EASTERN CONNECTICUT ENVIRONMENTAL REVIEW TEAM REPORT

*Greenbriar
Riding
Club
Estates*

Ledyard, Connecticut

REVIEW DATE: NOVEMBER 8, 1990

WATERSHED BOUNDARY MAP

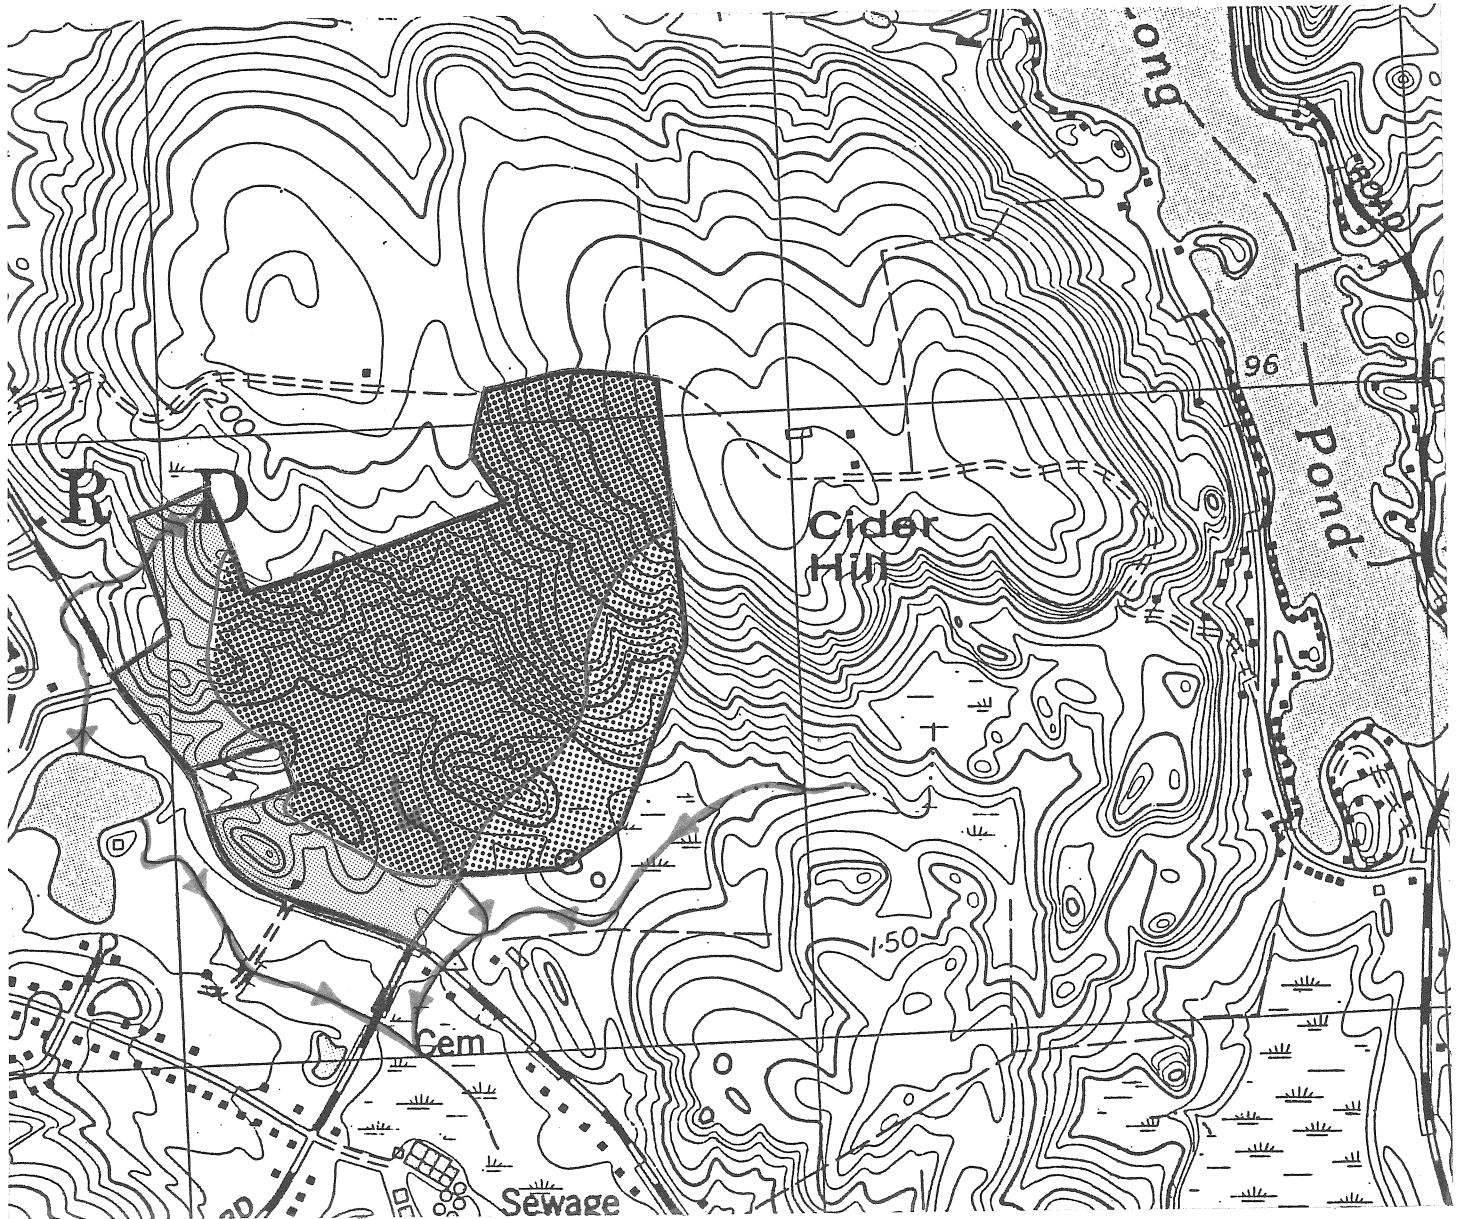
The proposed post-development water management plan will utilize a control structure (detention basin) and techniques to avoid net increases in peak flows discharging from most of the site for the 2, 5, 10, 25, 50 and 100 year storm events. The stormwater detention facility consists of an earthen berm, which will be constructed as part of the subdivision road to retain stormwater and a pre-fabricated outlet control structure to regulate stormwater discharges from the site to downstream areas. Because the stormwater control facility affects an area greater than 100 acres, it may be necessary to obtain a diversion permit from DEP's Inland Water Resources Unit. Robert Gilmore should be contacted (566-7160) regarding this potential permit. Close examination of all culverts passing under Shewville Road that convey water from the western limits of the site to Williams Brook and that is now part of the proposed stormwater management structure is warranted.
